GEORGETOWN-SCOTT COUNTY PLANNING COMMISSION

**UK FEDERAL CREDIT UNION
PRELIMINARY DEVELOPMENT PLAN
Staff Report for the Georgetown-Scott County Planning Commission
April 9th, 2026**

Staff Report to the Georgetown-Scott County Planning Commission

FILE NUMBER: PDP-2026-15

SHEET TITLE:
LANDSCAPE PLAN

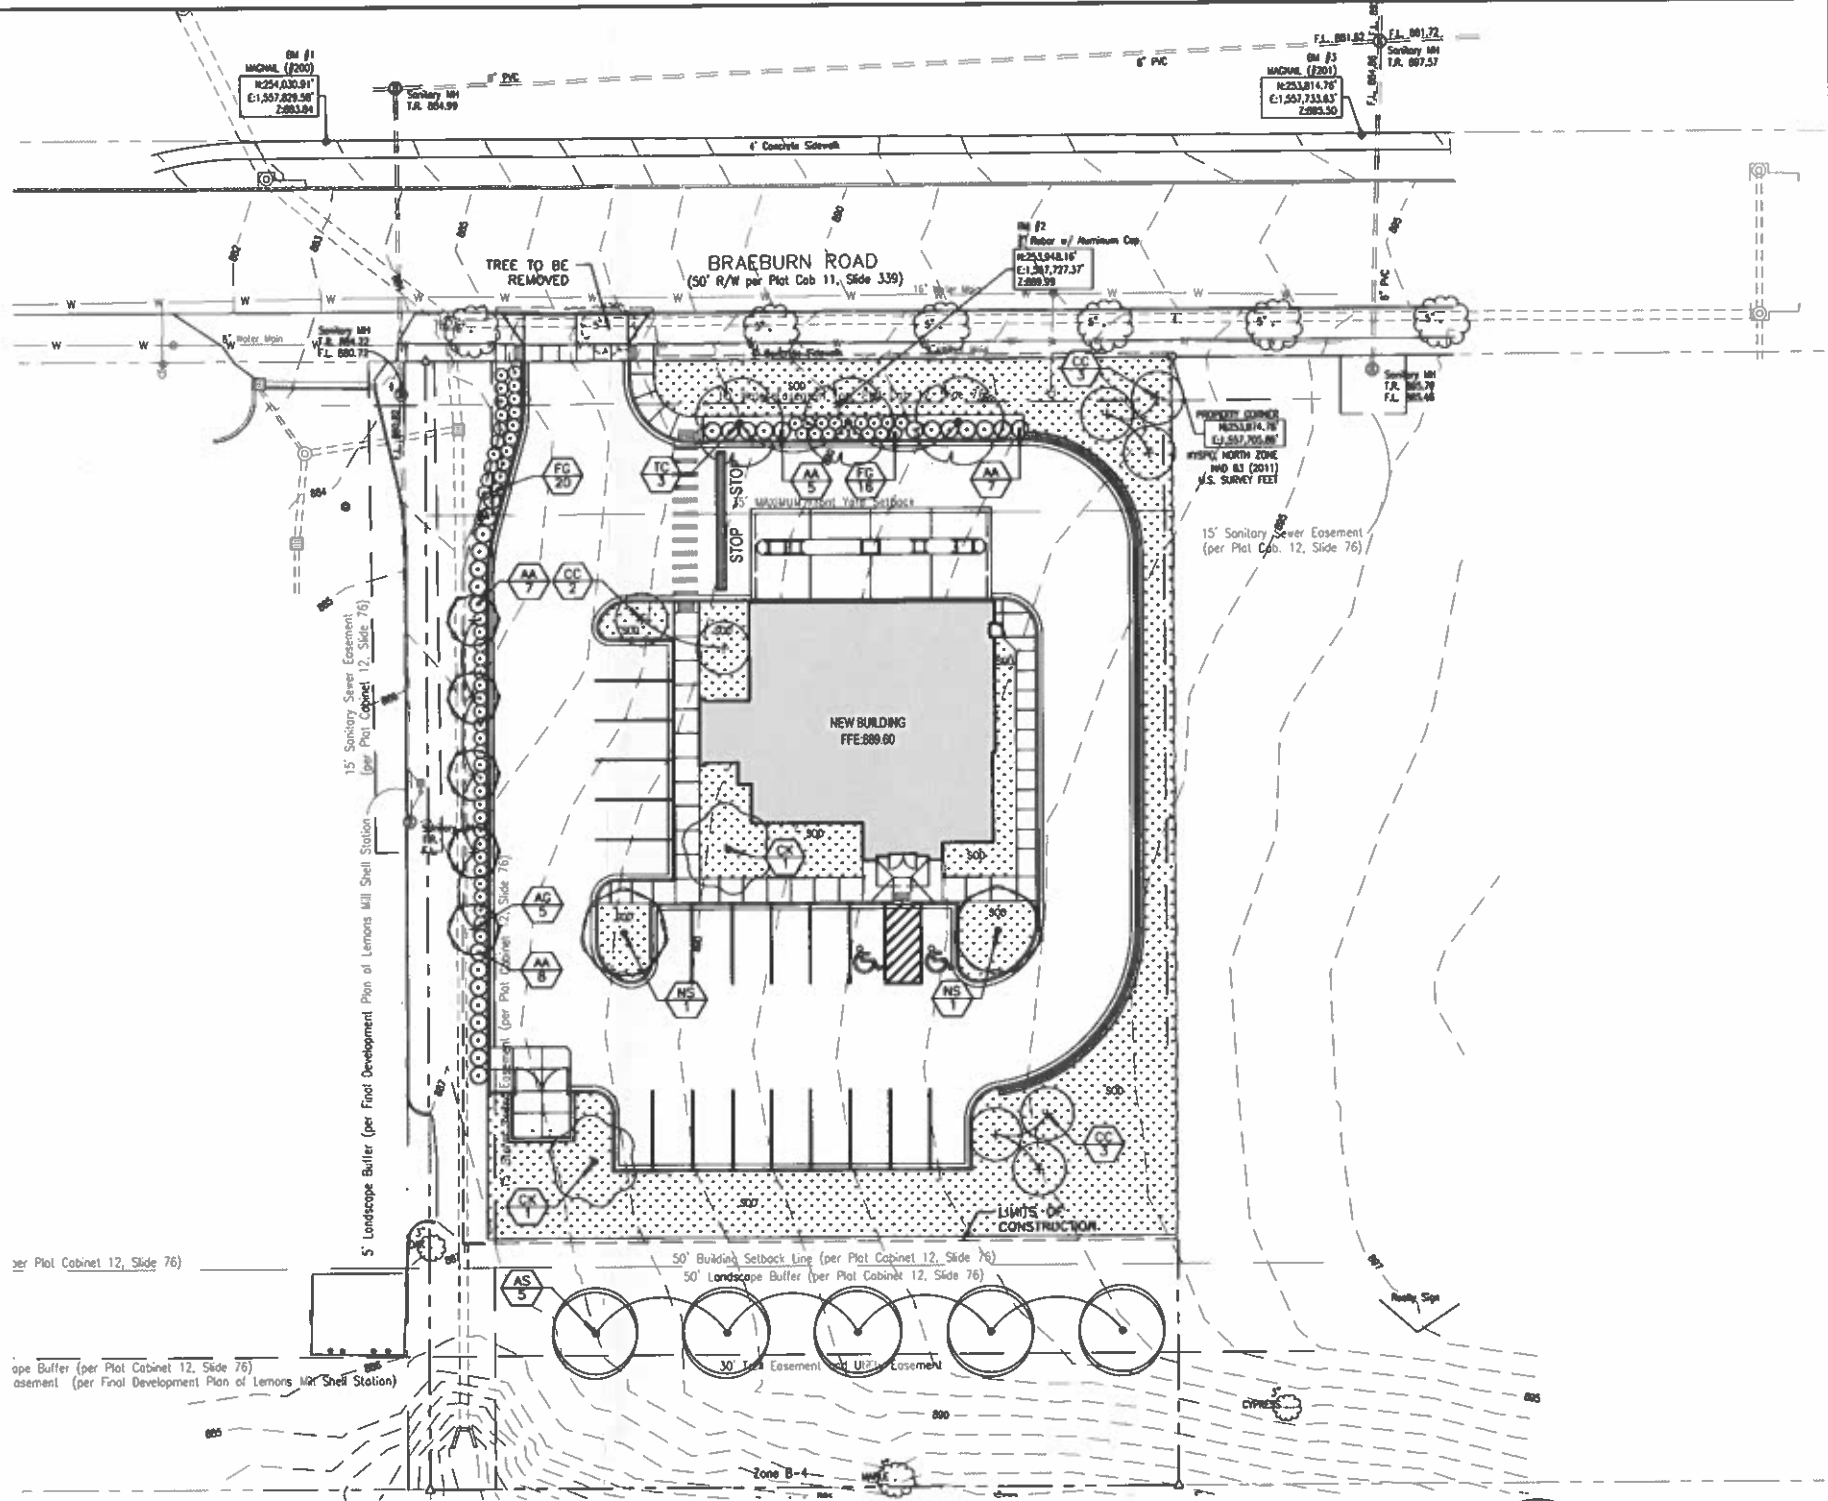
Under the literal interpretation of the provision of this article, the six-foot no-climb boundary fence would be required upon the common boundary with the A-1 land to the west of the site (bottom of plan). The applicant has requested a waiver from the provisions of this article based on the incompatibility with the future planned Legacy Trail extension to run upon the site.

Upon review of the waiver request, staff makes the following findings. First, the A-1 zone to which this property is adjacent is not any sort of agricultural use; it is McClelland Circle. Second, the fence is incompatible in nature with the planned extension of the Legacy Trail along the northwest boundary of the parcel. Third, the required fifty-foot setbacks and landscape buffer, shown on the plan, will provide adequate degree removal and/or screening for the development.

The *Landscape and Land Use Buffer Ordinance* requires a minimum tree canopy coverage area of 24% for commercial land uses that do not have any preserved coverage area (6.2215). The site will require such a minimum canopy coverage of 24%. The preliminary development plan/landscape sheet indicates a total canopy area of 12,550 square feet in total or 28.8% of the lot. The application exceeds the minimum canopy requirement.

The *Zoning Ordinance* requires that "*Street trees shall be required at a standard of one tree per every 40 linear feet of the individual property. Placement and maintenance shall be the responsibility of the land owner*" (4.444.H). The application meets this requirement, though staff finds a single complication pertaining to it. Two such street trees along Braeburn Road (one upon both sides of the entrance as shown upon the plan) create a potential safety issue due to limiting visibility within the sight triangle of the entrance. The *Subdivision and Development Regulations* states that "*There shall be no objects, manmade or natural, above ground level within the corner sight triangles*" (1000.P.6). Staff recommends that these two trees within the sight triangle of the entrance are removed from landscaping plans prior to submission of Final Development Plan due to safety concerns.

3. Staff recommends **approval** of the waiver from the *Landscape and Land Use Buffer Ordinance* (6.14) in the form of waiving the requirement of a 6-foot-tall no-climb boundary fence adjoining the A-1, based on the following findings:
 - a. The A-1 zone to which this property is adjacent is not an agricultural use.
 - b. The fence is incompatible in nature with the planned extension of the Legacy Trail.
 - c. The required fifty-foot setback and fifty-foot land use buffer will provide adequate degree of removal and screening for the development.

FRONT ELEVATION - PROPOSED SIGNAGE
SCALE: 1/16" = 1'-0"

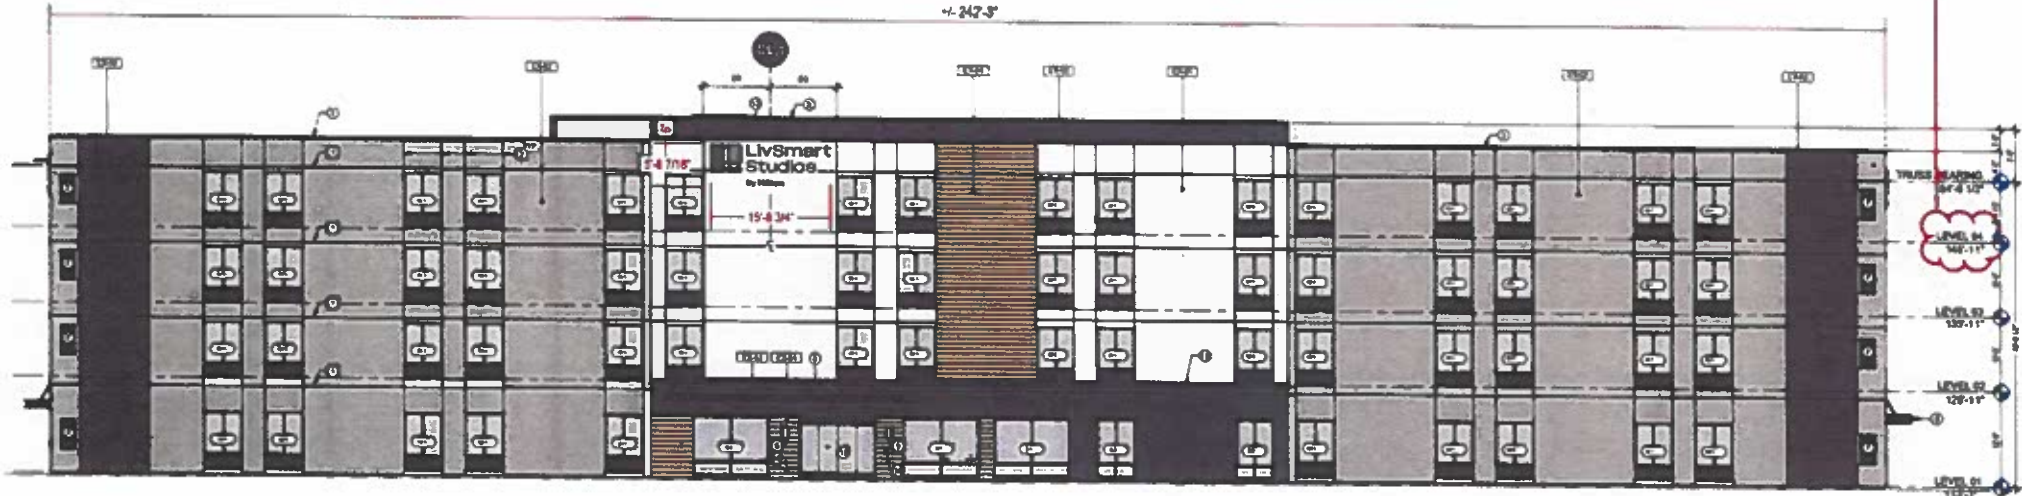
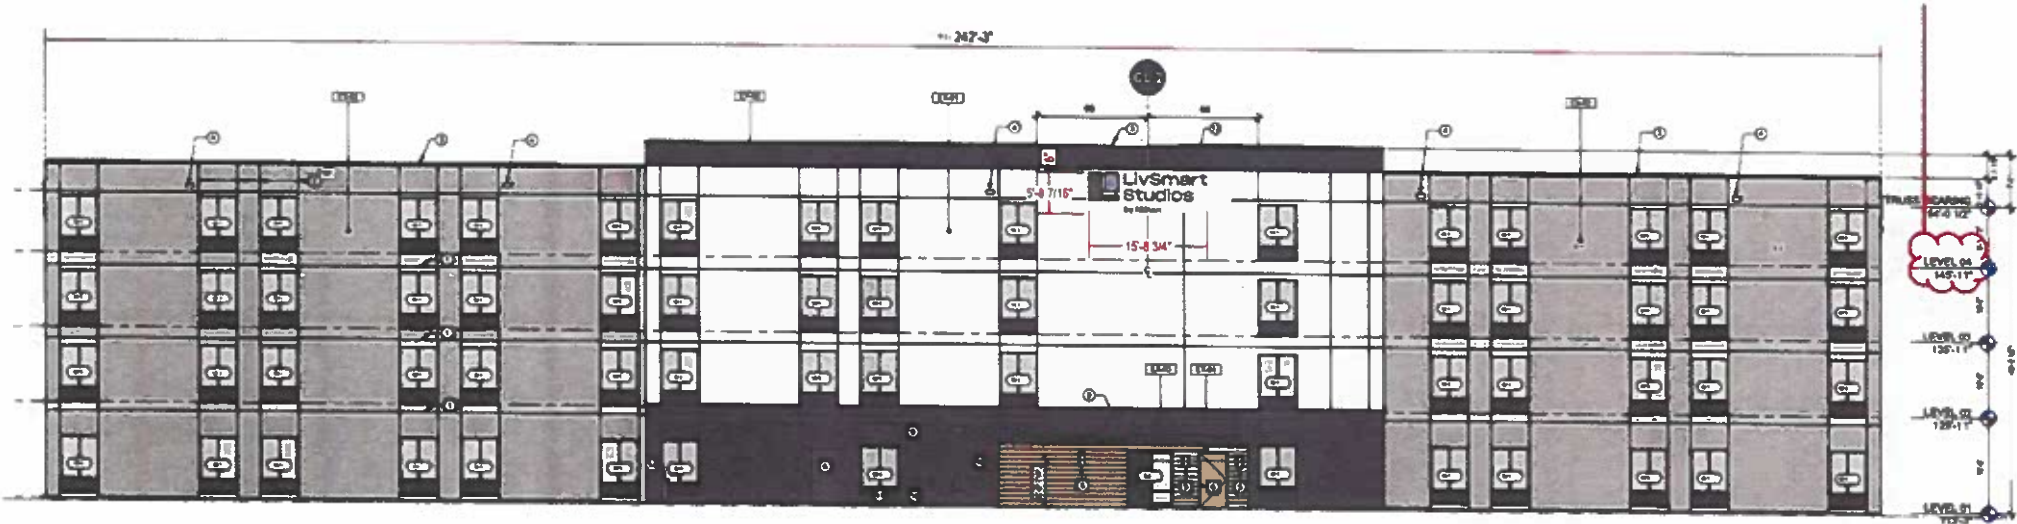
The Applicant has included a sign plan for the proposed development. The proposal includes one monument sign located at the entrance and two wall signs located on the north and south façades of the building. The freestanding sign regulations for the B-2, Highway Commercial, zone are as follows:

Due to the site layout, building orientation, and circulation patterns, the applicant proposes to show signage on the broad front and rear sides of the building rather than the narrow ends.

The requested variance does not increase the number of signs, sign area, or intensity beyond what is otherwise permitted. It only modifies the orientation of wall-mounted signage to increase visibility.

DEVELOPMENT PLAN

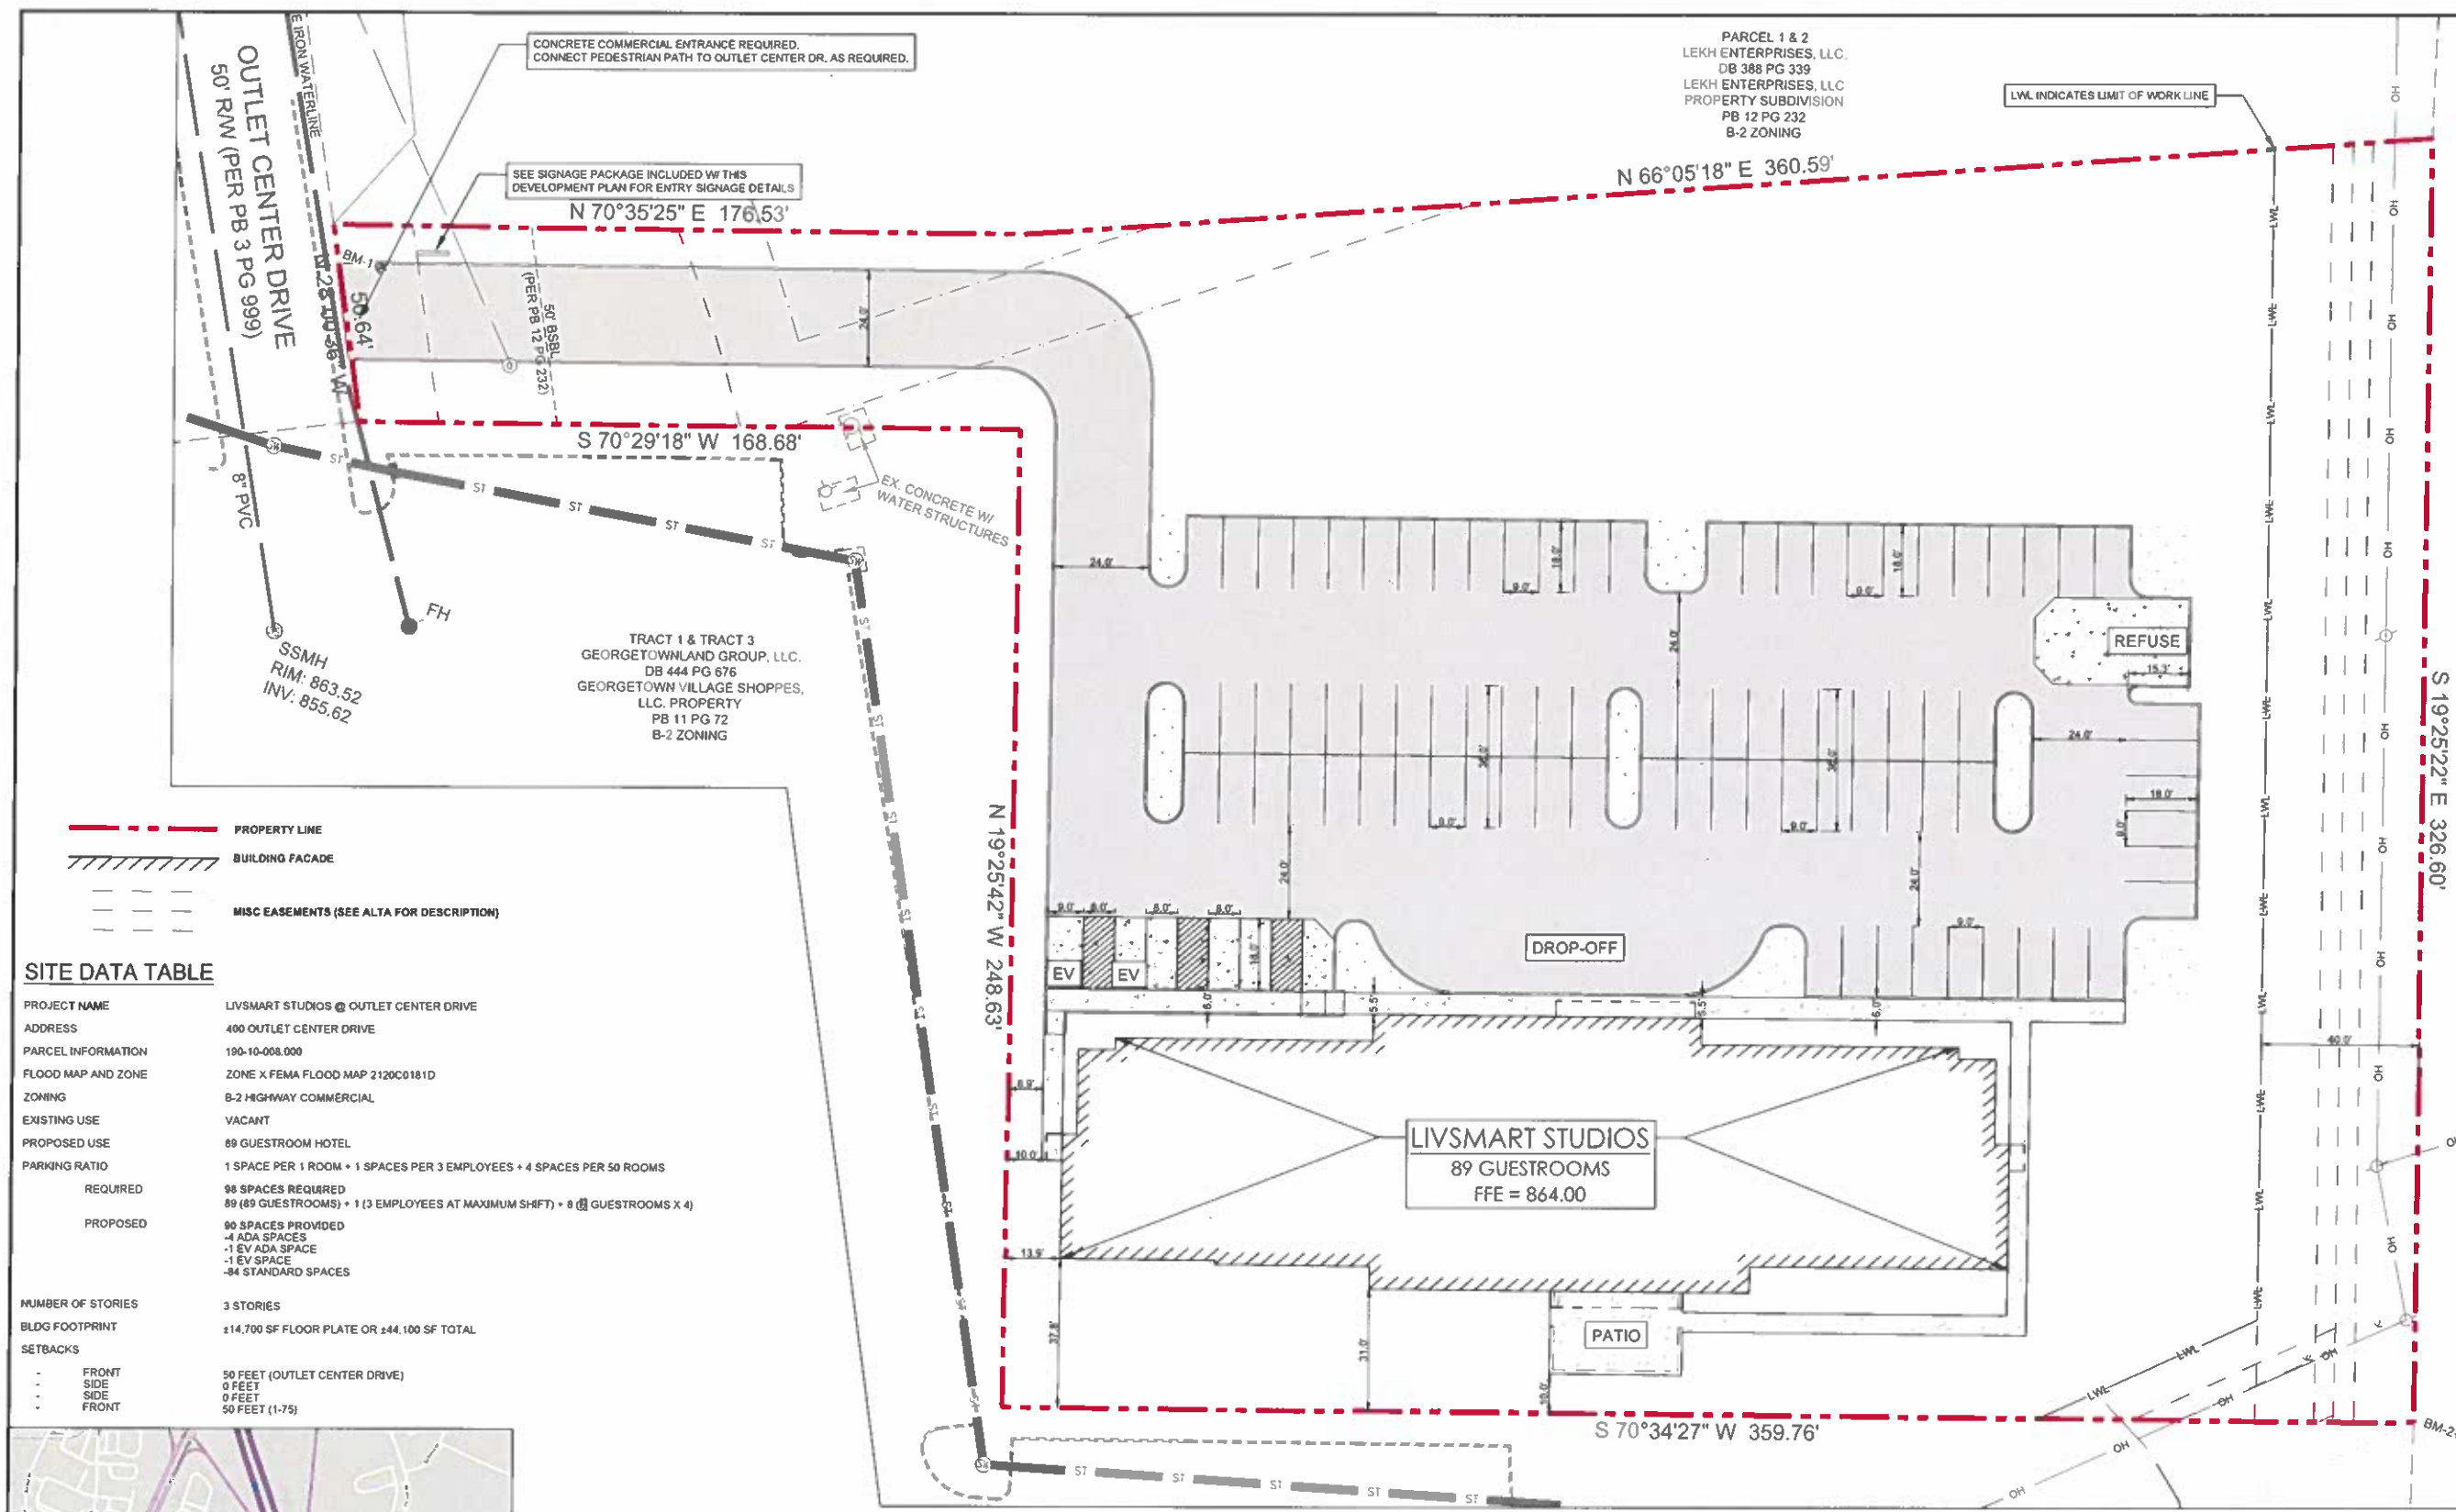
The development plan depicts a driveway from Outlet Center Drive to a 90-space parking lot and 3-story hotel with first floor area of 14,700 SF. The building is shown along the south boundary of the parcel.

Per the *Subdivision & Development Regulations*, hotels require one parking space per room, one space per three employees, and four additional spaces per 50 guest rooms, or in the case of the Project Site 98 parking spaces (with 4 ADA spaces). The Applicant requests a waiver to this requirement, instead proposing allocating one parking space for each hotel room plus one additional space for staff. The development plan shows the Project Site having 90 parking spaces; 1 being designated for electric vehicles, and 5 being designated as ADA accessible (4 standard and 1 for ADA electric vehicles).

In a supplemental letter submitted by the Applicant, they state that the typical business model for a hotel result in a "staggered parking demand" where there is limited overlap between guests, variation in check-in/check-out times, and single-vehicle guest arrivals. Furthermore, the Applicant notes that the industry standard is one space per room for limited-service and select-service hotels, which they state the proposed use satisfies as the hotel does not provide conference room nor other ancillary uses typical for all-service hotels. Finally, the Applicant states reducing the number of parking spaces would reduce the environmental impact of site development as additional parking areas would increase impervious area and stormwater runoff while reducing the area for landscape buffer installation.

The *Landscape & Land Use Buffers Ordinance* requires an interior landscaped area 10% the size of the VUA and for those areas to be populated with 1 tree per 250 square feet of interior landscaped area. The plan shows 38,718 SF of VUA, equivalent to 3,972 SF of ILA required for the property. The Applicant requests a waiver to the requirement to install 6.5% ILA, equivalent to 2,518 SF of ILA on the property, and 13 ILA trees.

Staff recommends **Approval** of the Preliminary Development Plan for a 3-story hotel with 89 guest rooms at the property addressed 400 Outlet Center Drive. If the Planning Commission approves the application, staff recommends including the following waivers/variances and conditions of approval:
